RE: Pitre KIA – Site Plan EPC

CONDITIONS OF APPROVAL-PR-2024-011052, SI-2024-01468 – Major Amendment to Site Plan – EPC

Per the conditions of approval dated November 21st, 2024, please find the following responses addressing the comments listed below:

ELECTRICAL SITE PLAN

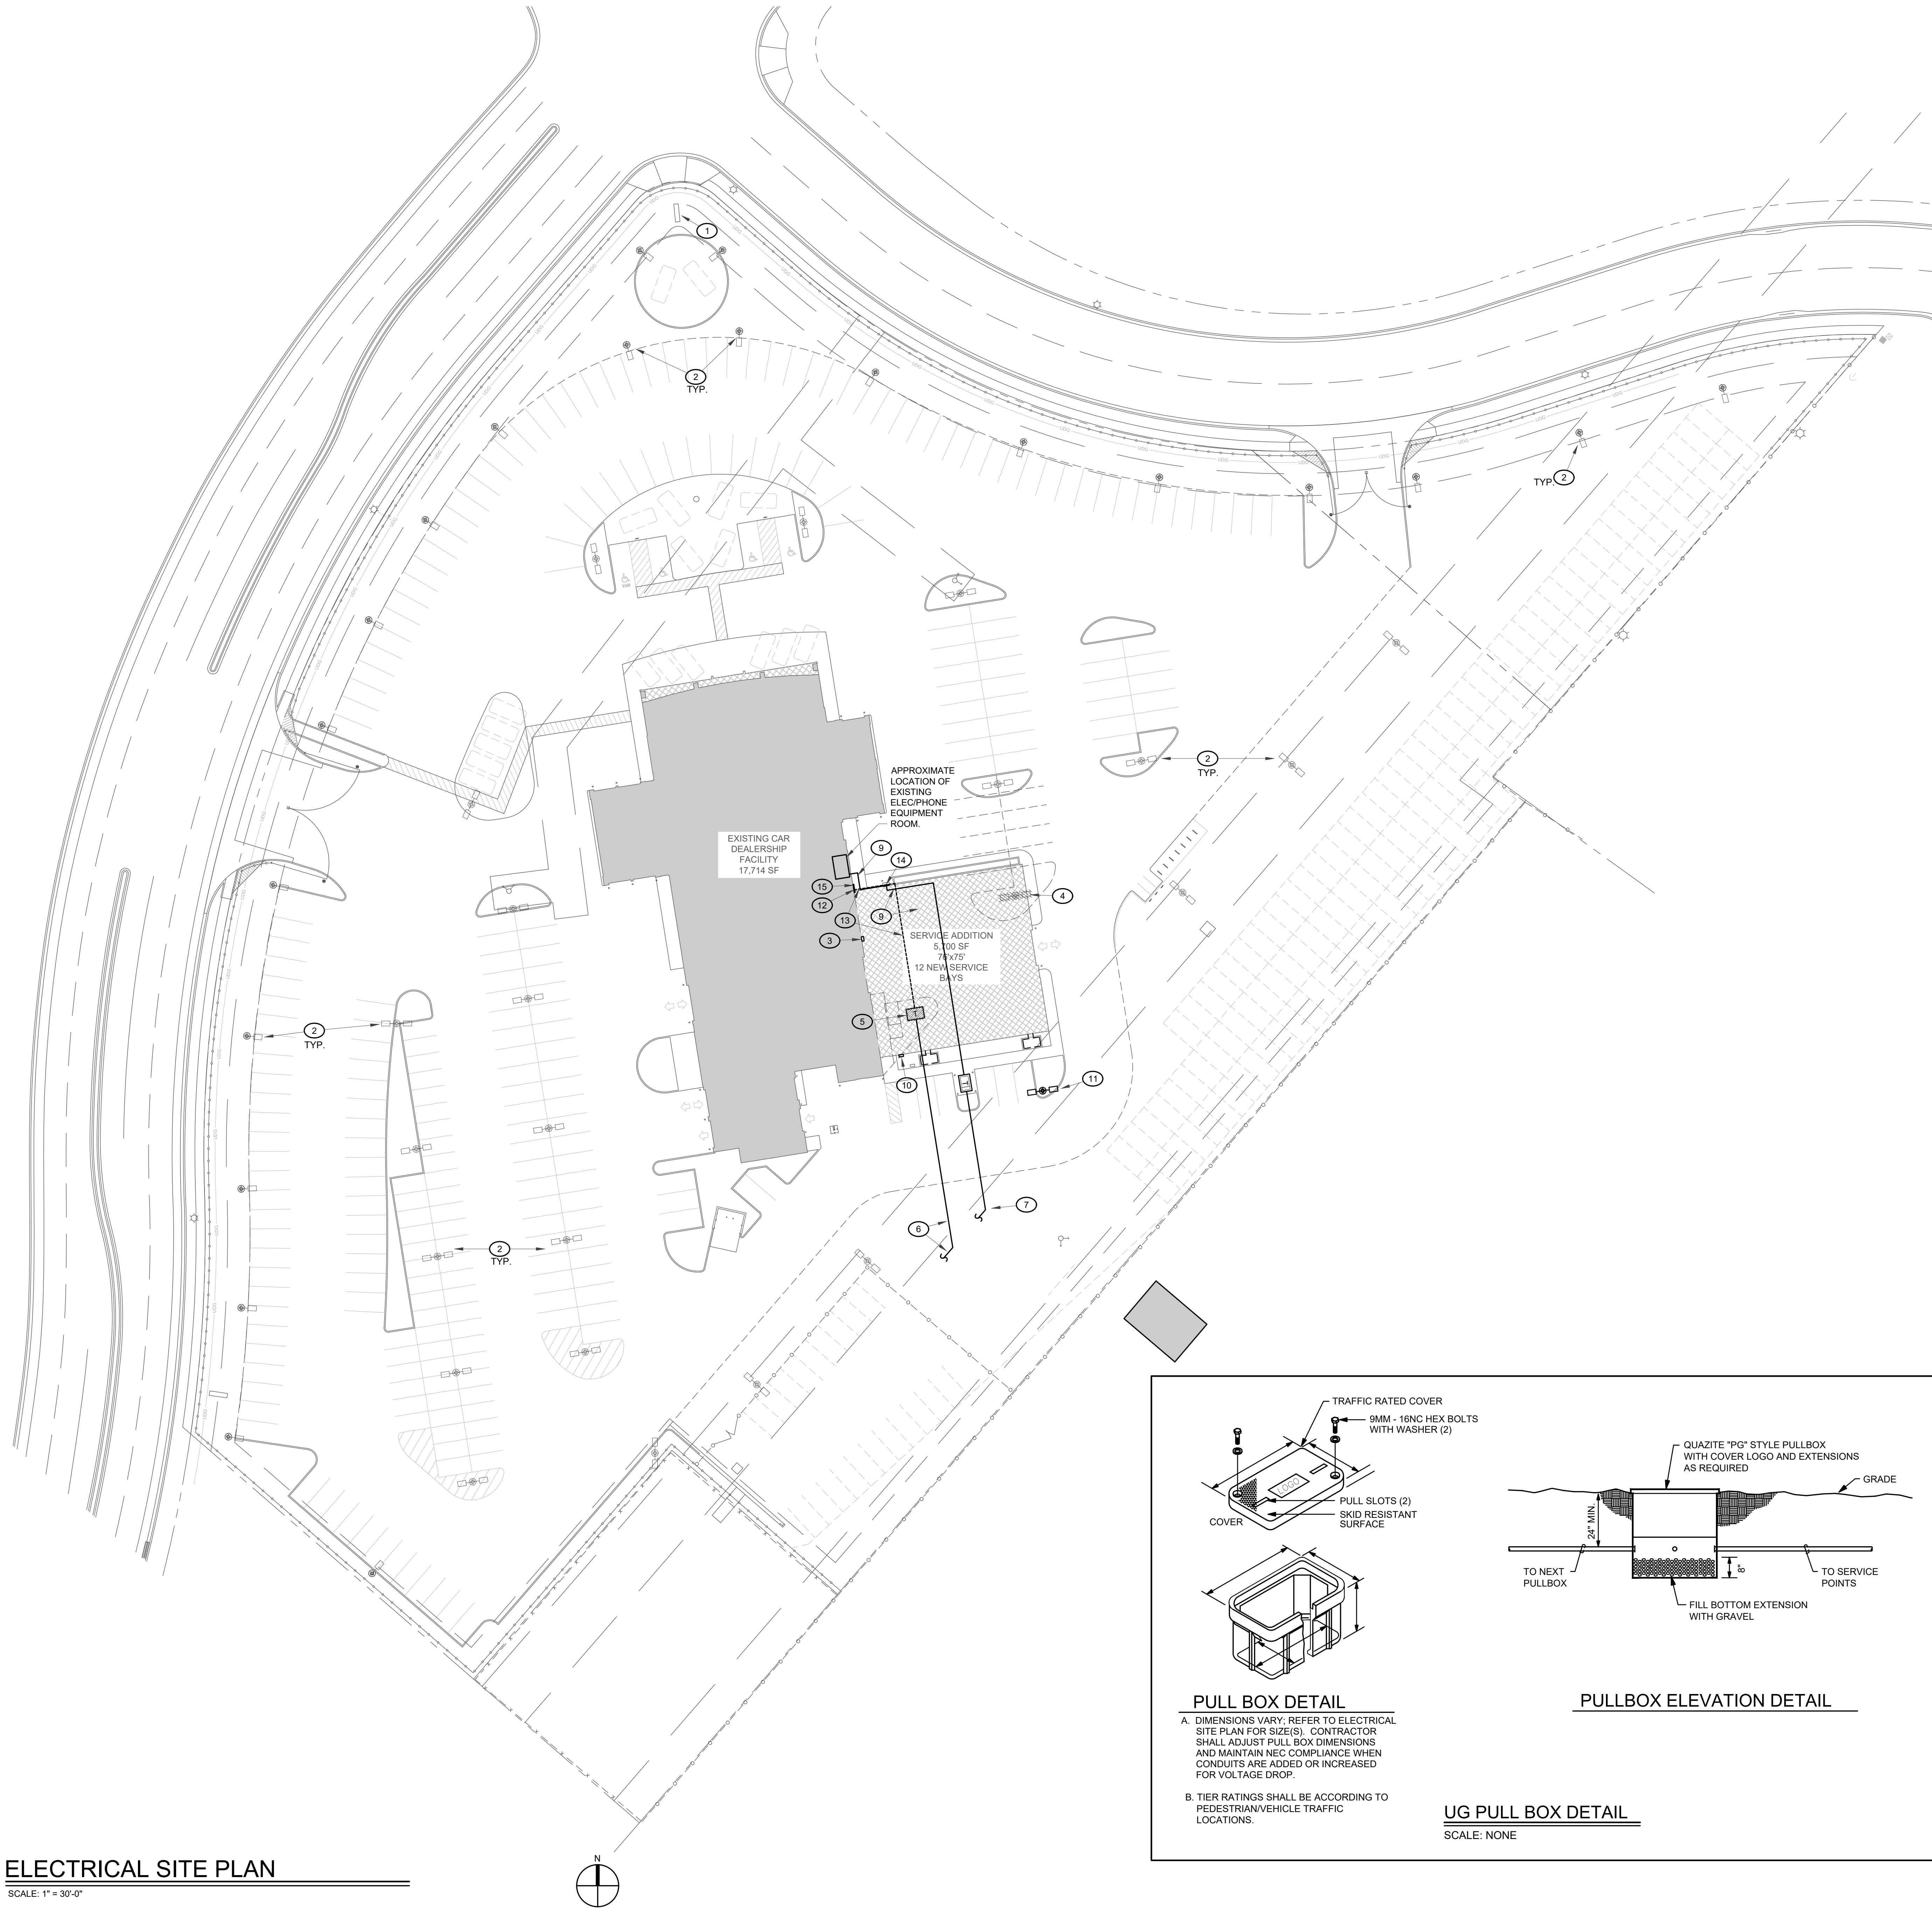
8. The site lighting shall come into compliance with the Outdoor and Site and Light standards of IDO §14-16-5-8 or the applicant shall show how the existing outdoor lighting complies with the IDO. A site lighting plan shall be provided to city staff prior to sign off. If the applicant is unable to comply with IDO §14-16-5-8 they shall return to EPC for an outdoor and site lighting performance analysis.

Applicant Response: Site lighting sheets (E0.1 & ES1.0) in compliance with the IDO are attached to this letter.

ROUGH GRADING APPROVAL		DATE
 RONALD R. BOHANNAN P.E. #7868	KIA WESTSIDE AUTO DEALERSHIP	DRAWN BY RMG
	GRADING AND DRAINAGE PLAN	DATE 11/06/2024
 TIERRA WEST, LLC 5571 MIDWAY PARK PLACE NE ALBUQUERQUE, NM 87109 (505) 858-3100 www.tierrawestllc.com		SHEET # GR-1
		JOB # 2024019

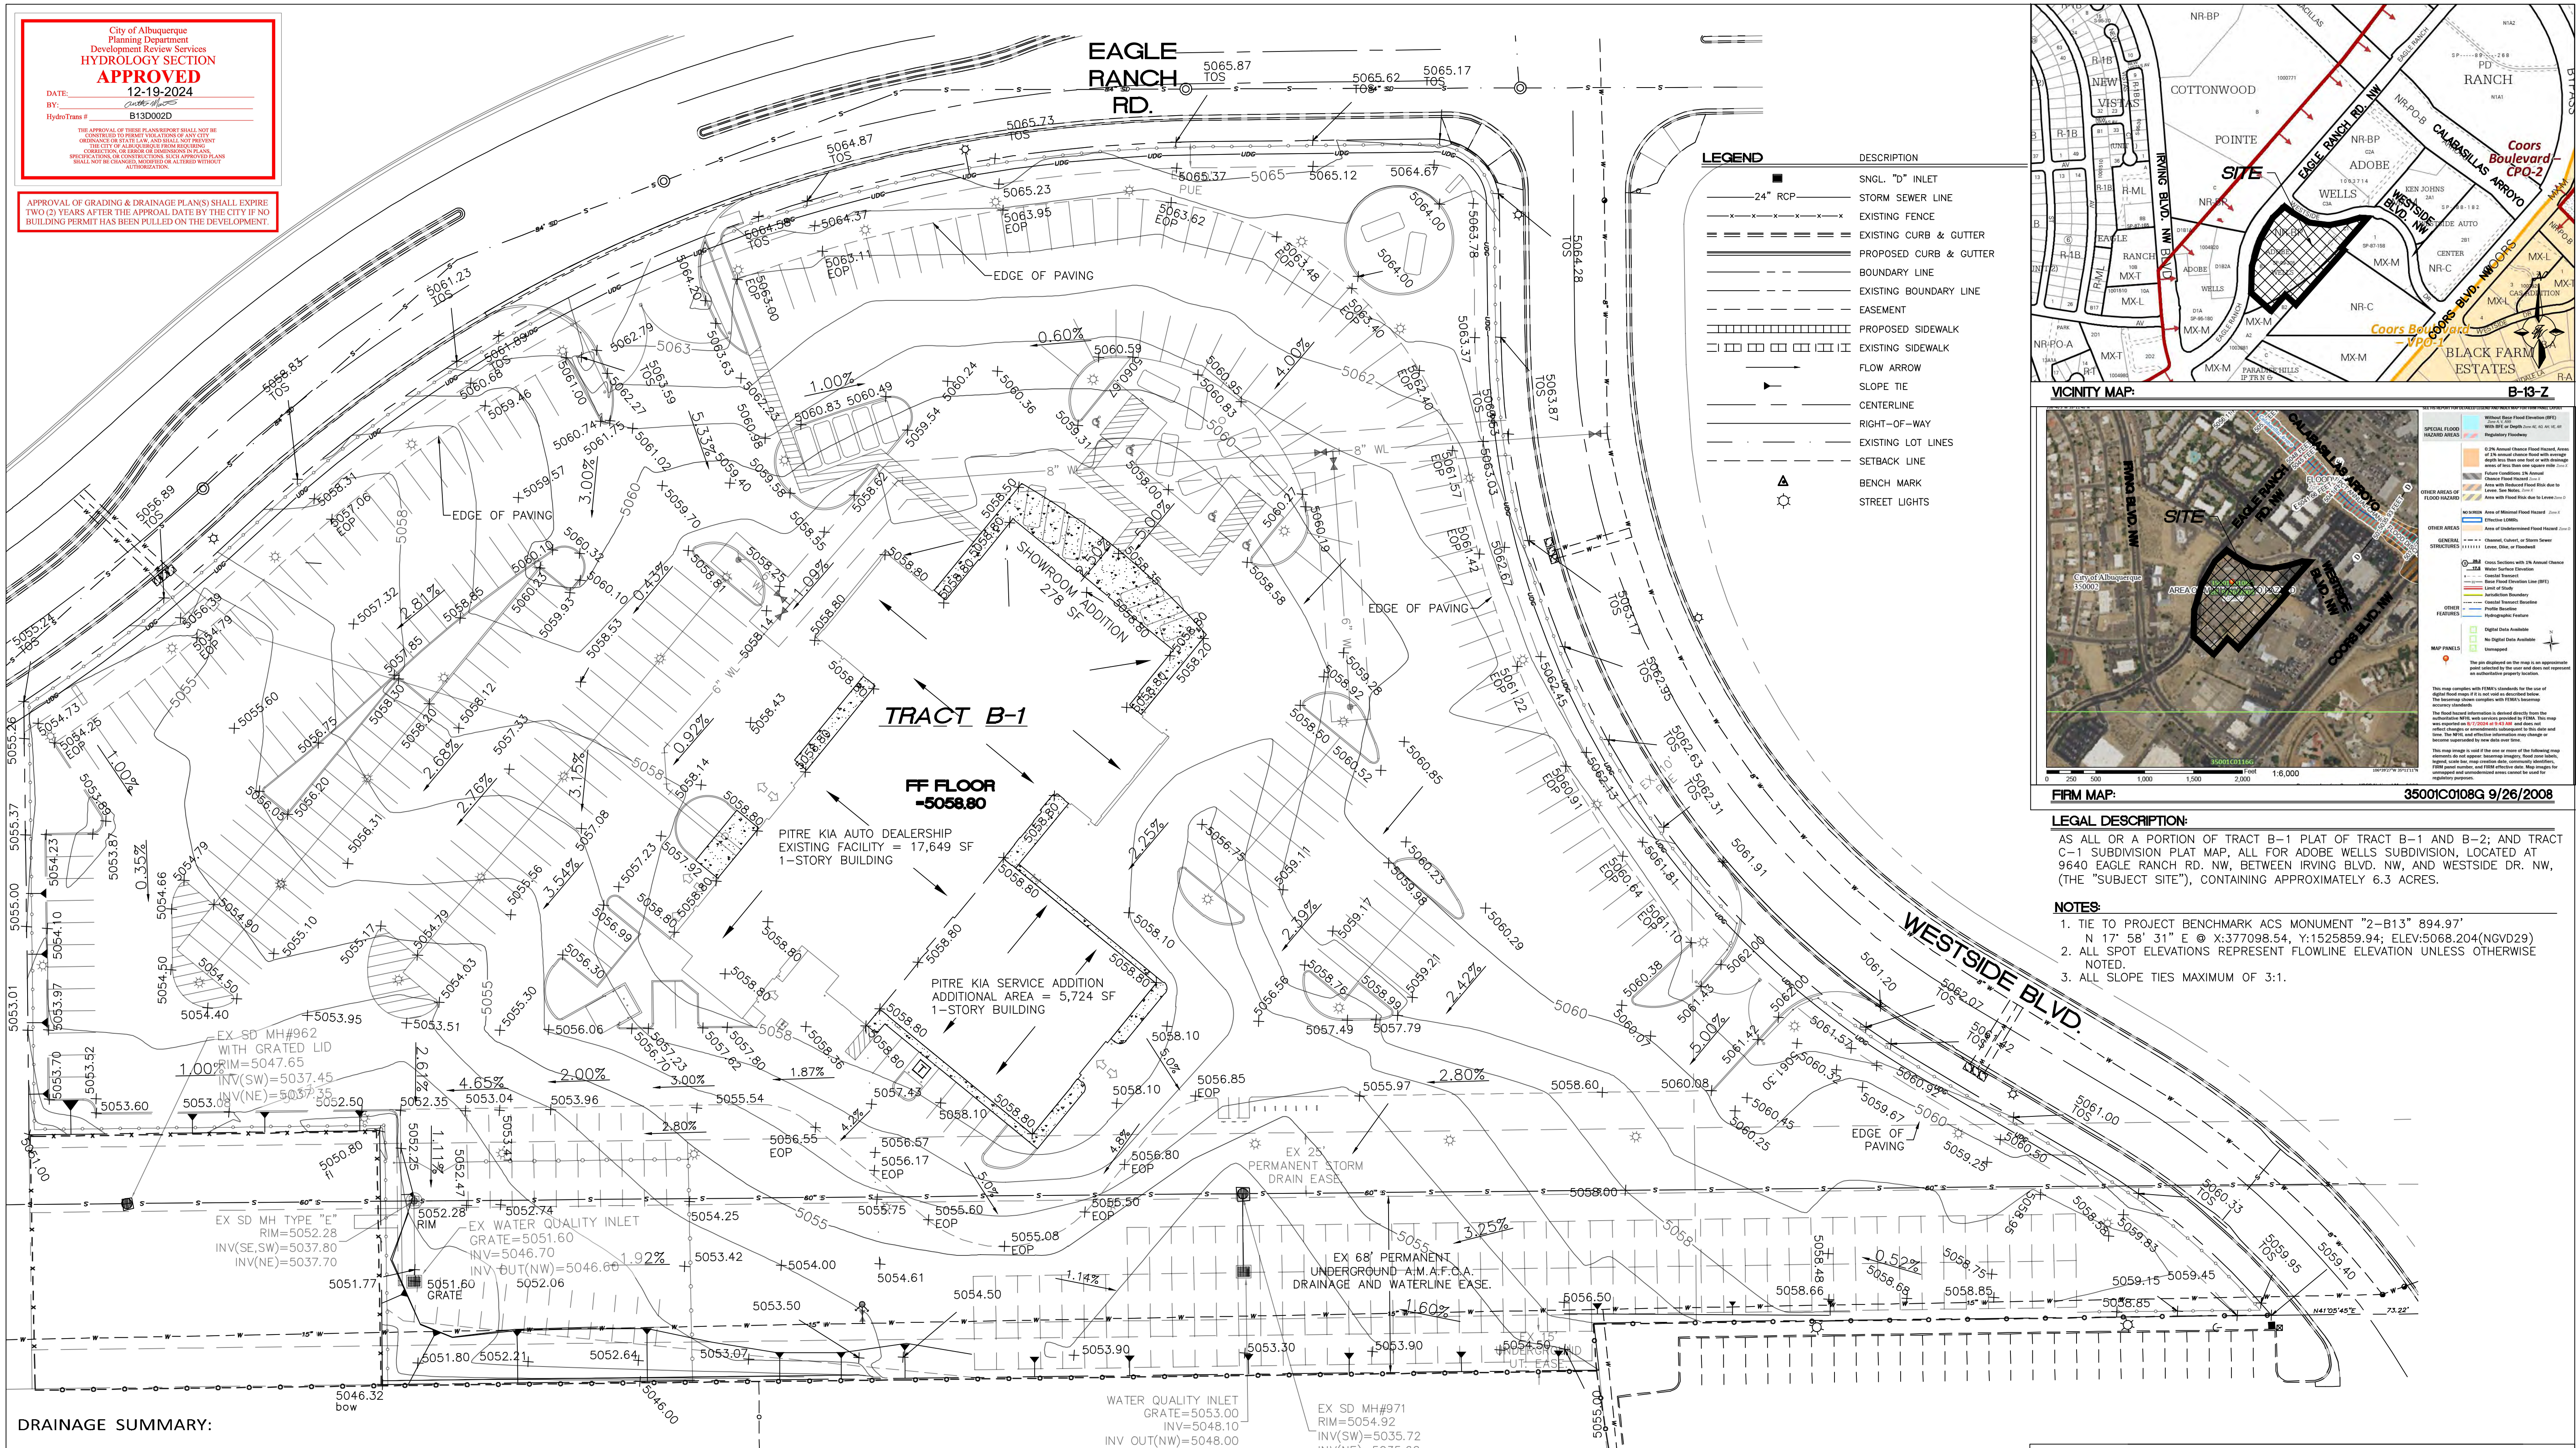
A Grading and Drainage Plan & Report must be approved by Hydrology prior to review/sign-off of the Site Plan by the DFT. Stormwater Quality Volume (SWQV) - The total required SWQV calculation must be included on the Grading and Drainage Plan along with Calculation of the portion of the SWQV for which payment-in-lieu is requested. Payment shall be made at the following steps in the City review/decision process:

1. Multi-family Development: Prior to the issuance of a building permit.
2. *Commercial Development: Prior to the issuance of a building permit.* [emphasis added]
3. Single-family Subdivision: Prior to recording the Final Plat and prior to the issuance of a work order.

Applicant Response: Hydrology approval received and attached to this response letter. All calculations referenced above can be found on the Grading and Drainage Plan as required.
